FIRE SERVICES DEPARTMENT
FIRE SAFETY COMMAND
7/F, Fire Services Headquarters Building,
No. 1 Hong Chong Road, Tsim Sha Tsui East, Kowloon.
Hong Kong

13 May 2008

FSD Circular Letter No. 5/2008
Graphical Symbol Exit Signs

Figure 3 – Graphical Symbol Exit Sign

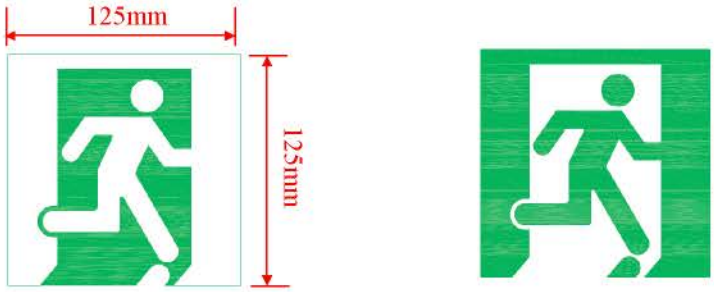
(c) Graphical Symbol Exit Sign (Figure 3)

- In this design, it is only a graphical symbol of not less than 125mm x 125mm. Figure 4 shows the details of the symbol.

Figure 4 – Detailed Scale of the Graphical Symbol

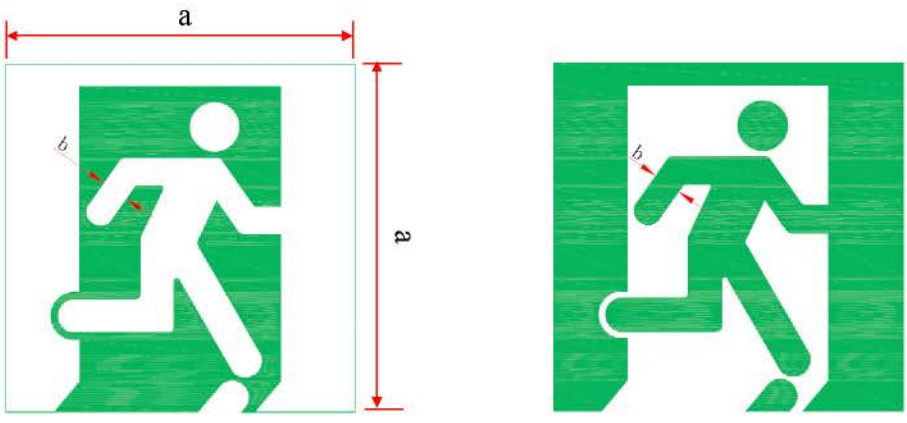
- A graphical symbol with dimension of not less than 125mm x 125mm shall be incorporated between the Chinese and English characters. Detailed scale of symbol is illustrated in Figure 4.

(Dimension: a ≥ 125mm and b ≥ 10mm)
